# SERVICE BULLETIN REVISION TRANSMITTAL SHEET

MODEL BD-700-1A11 (BD-700)

Service Bulletin No. 700-1A11-31-008  
Date of Basic Issue Aug 29/2006  
Revision No. 01 Dated Dec 14/2009

**MODIFICATION – FLIGHT DATA RECORDING-SYSTEM –  
 INTRODUCTION OF A QUICK ACCESS RECORDER**

**KGC991-0028** – Kit – Installation of Quick Access Recorder (QAR)  
(Sheet 1 of 1, Rev. A)

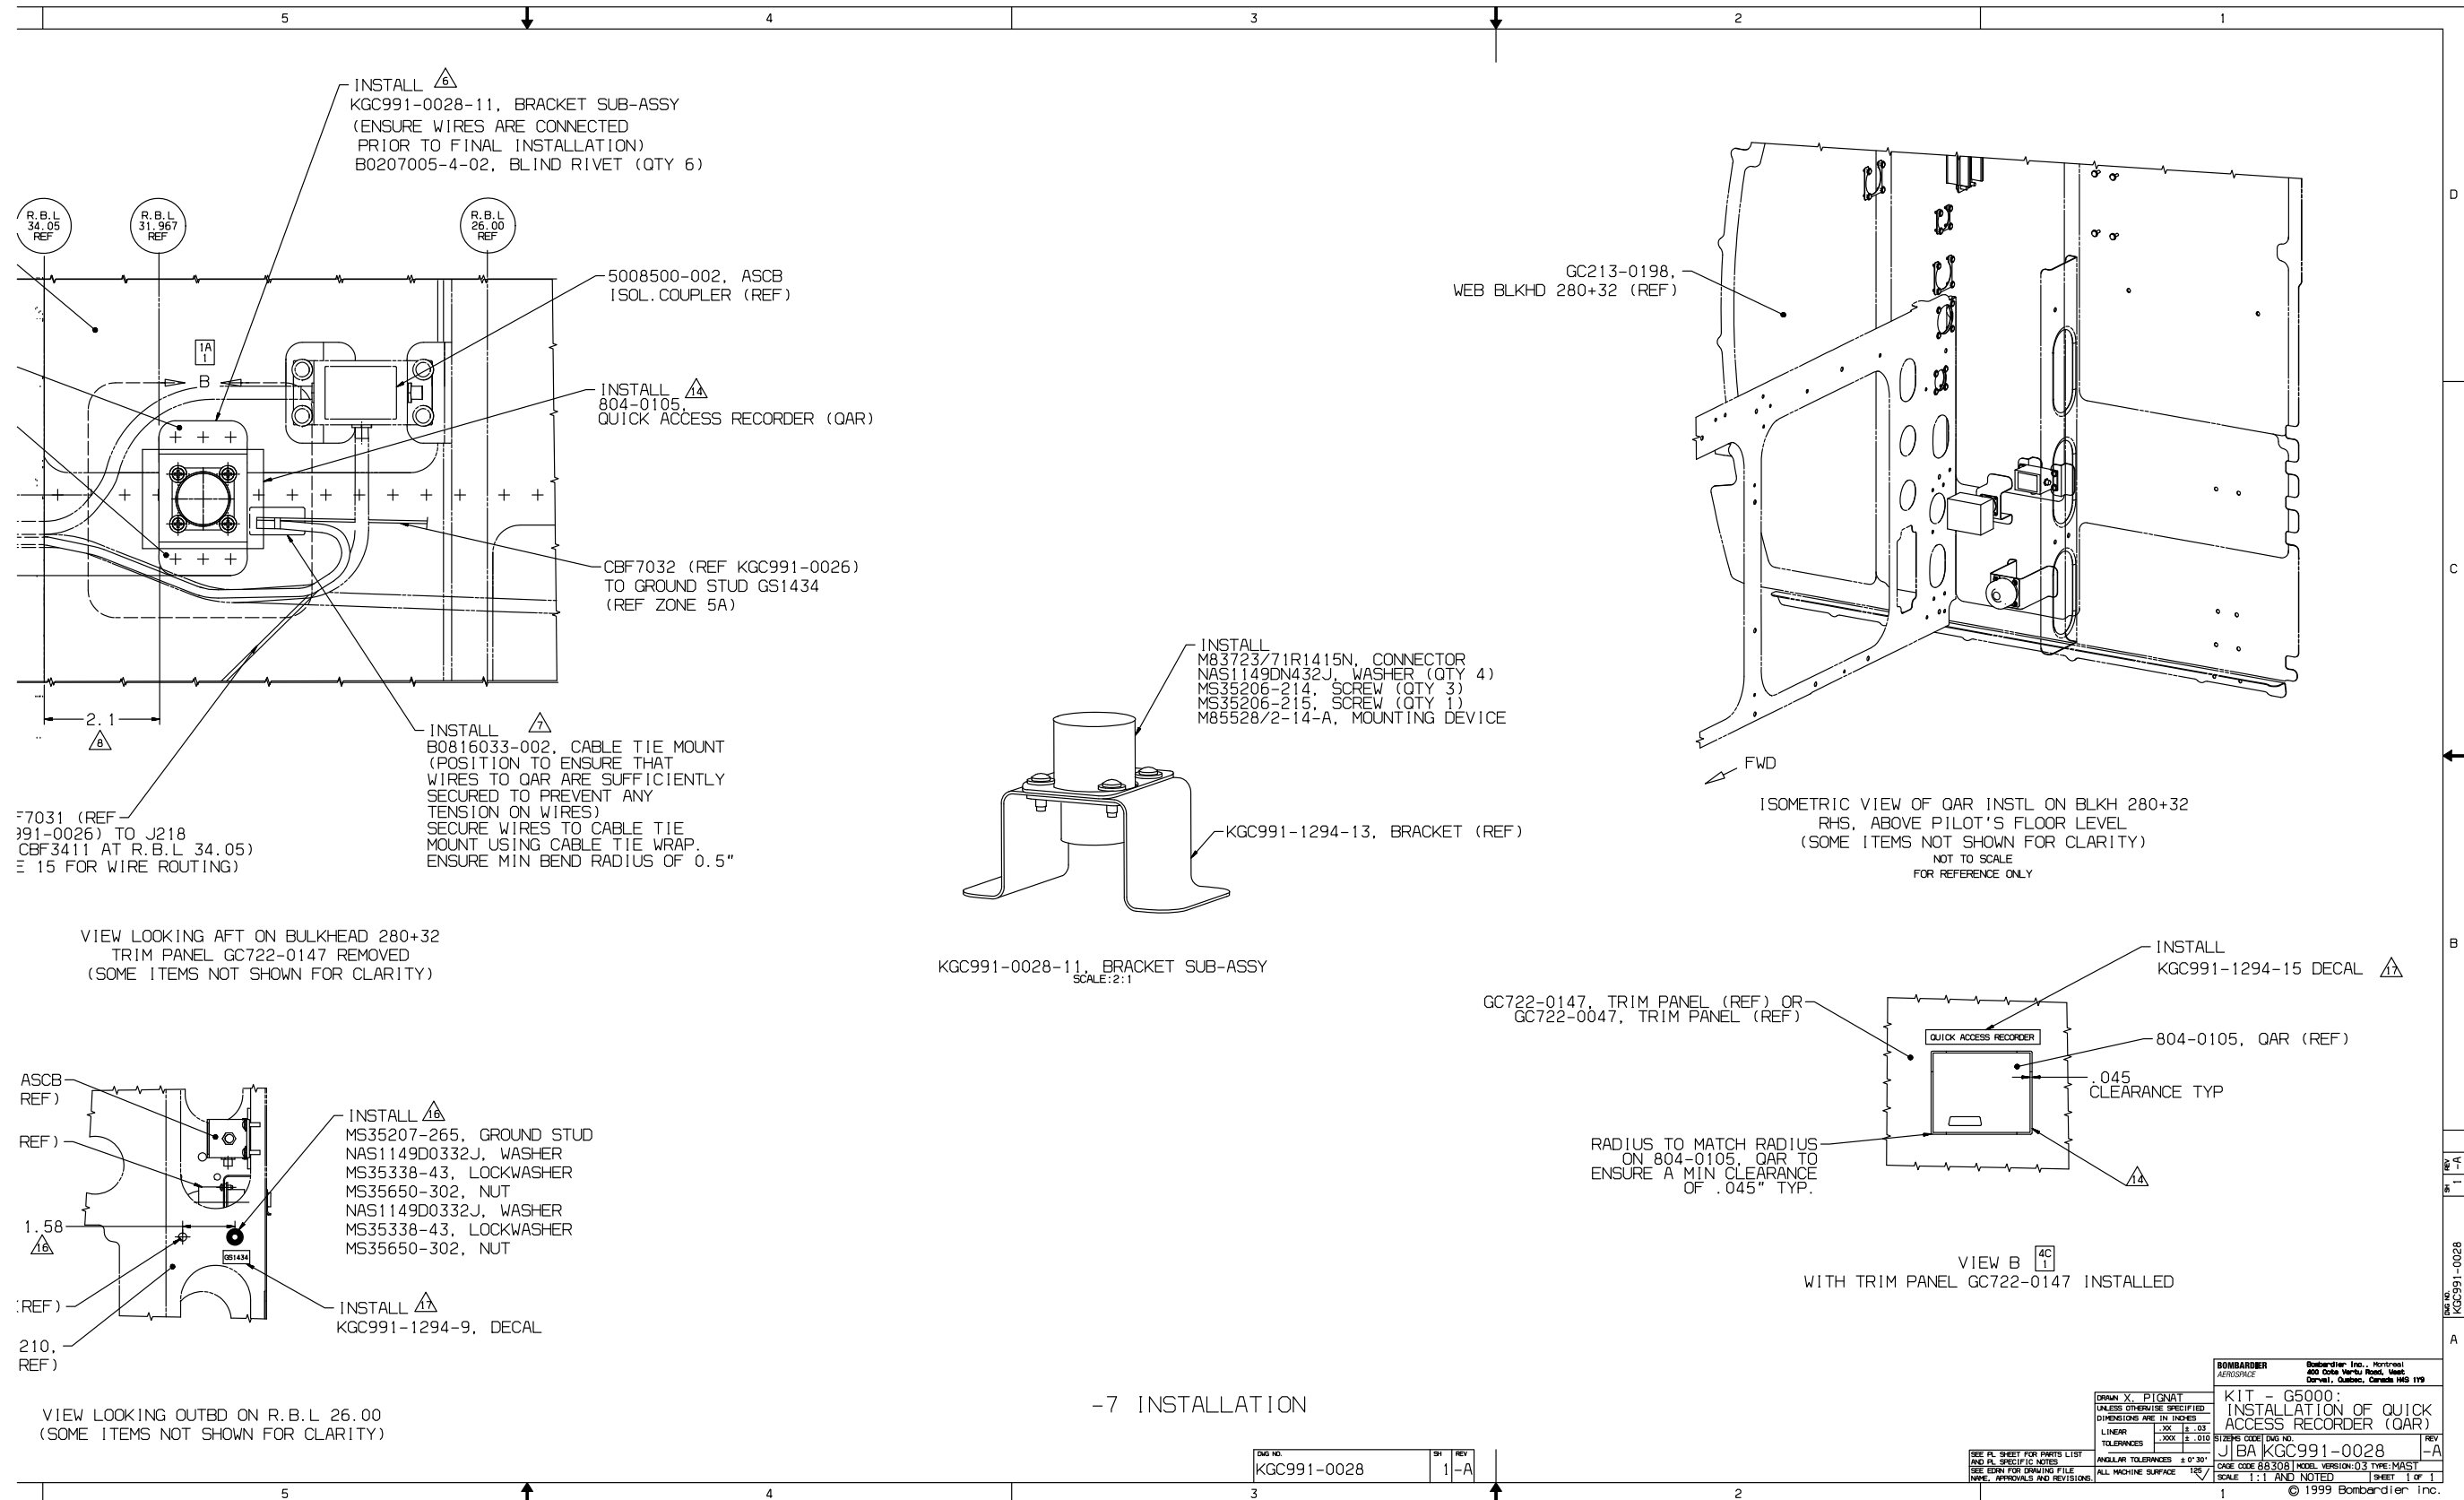
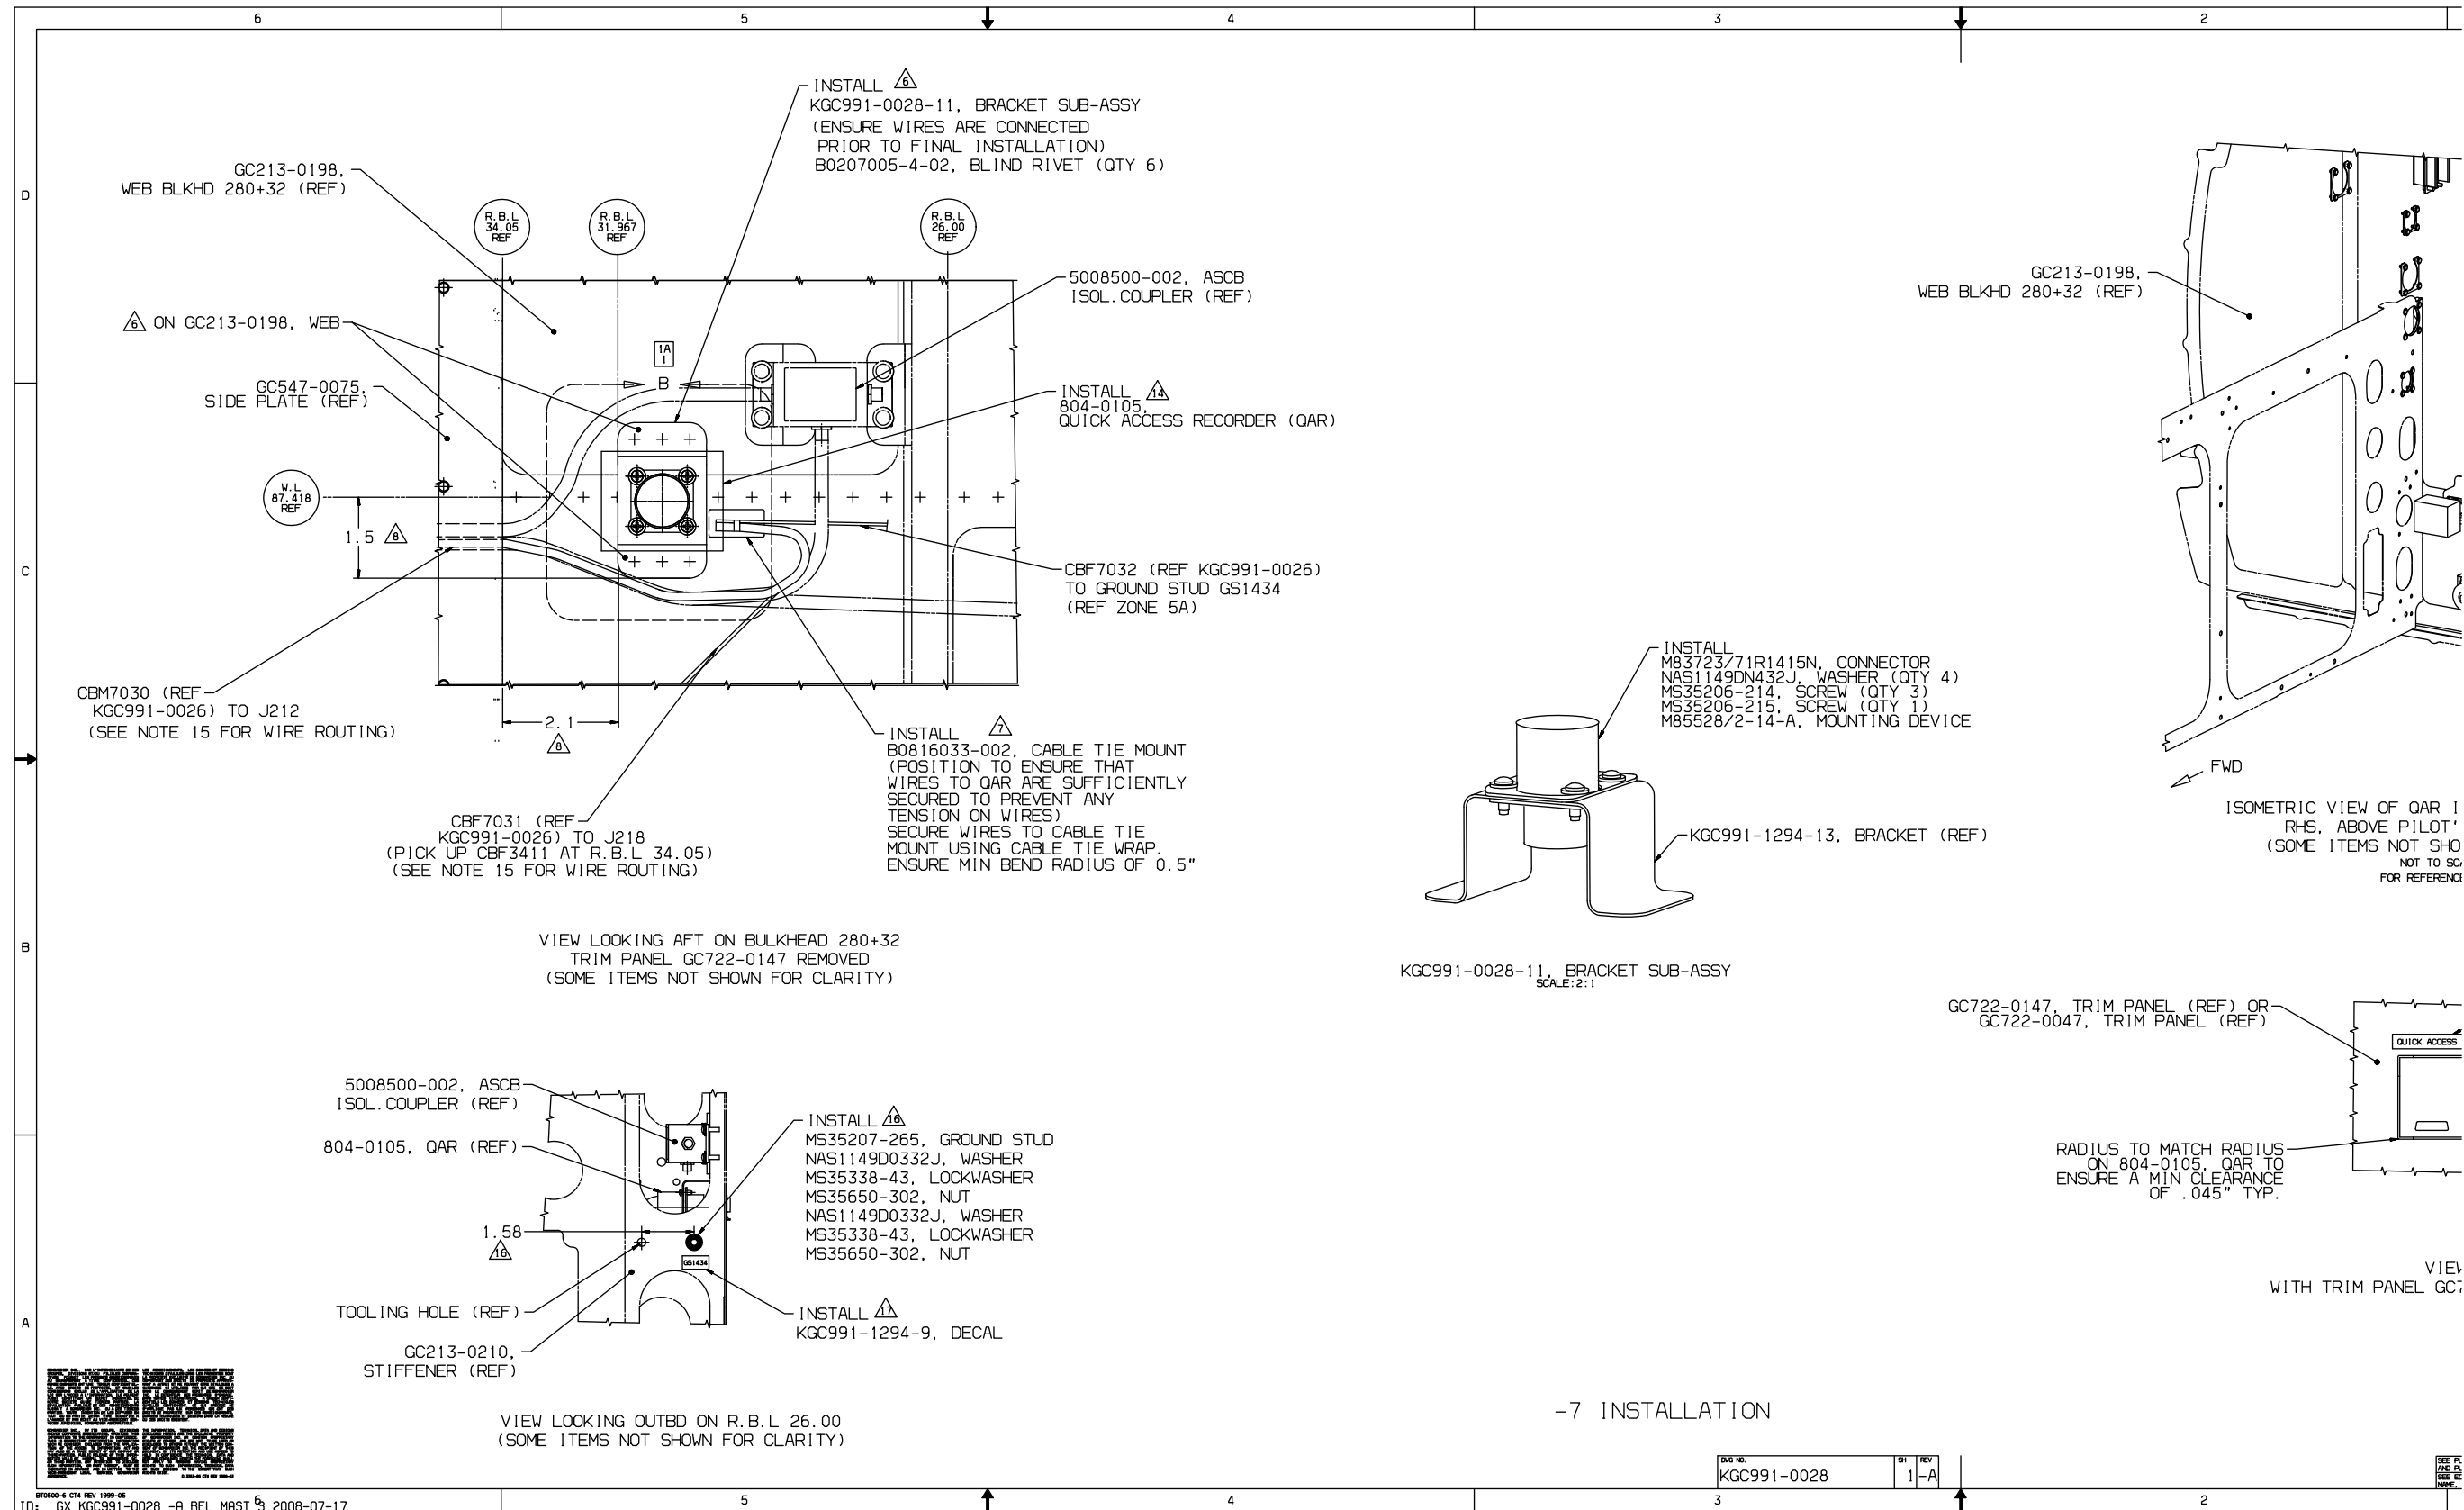
3. Change, in Paragraph 1.K., the revision of the Modification Summary R700T400229 from A to B and the revision of the Kit Drawing KGC991-0028 from -- to A and add the reference to the Illustrated Tool and Equipment Manual for the GSE.

4. Add a Note after step 2.B.(1) to clarify the position of the connector on the bracket sub-assembly to ease removal for maintenance.
5. Change, in Paragraph 2.B.(1)(a) and other subsequent locations, the part no. of the bracket sub-assembly KGC991-0028-3 to KGC991-0028-11.

6. Change, in Paragraph 2.B.2.(f)(iii), the part no. of the bracket KGC991-1294-5 to -13.

7. Change, in Paragraph 2.B.(5), the kit drawing number.
8. Add, in Paragraph 2.B.(7): "Install decal Part No. KGC991-1294-15 above cut out as shown on Kit Drawing KGC991-0028. Refer to TASK 20-80-01-400-801."

13. Replace revision -- of the Kit Drawing KGC991-0028 with revision A.
14. Make miscellaneous minor changes, as necessary, with no change of context.

NOTE: The connector, Part No. 83723/71R1415N included in the wire kit, must be mounted on the outside of the bracket sub-assembly as shown on sheet 2 of the kit drawing to ease removal for maintenance.

- (7) Install decal Part No. KGC991-1294-15 above cut out as shown on Kit Drawing KGC991-0028. Refer to TASK 20-80-01-400-801.
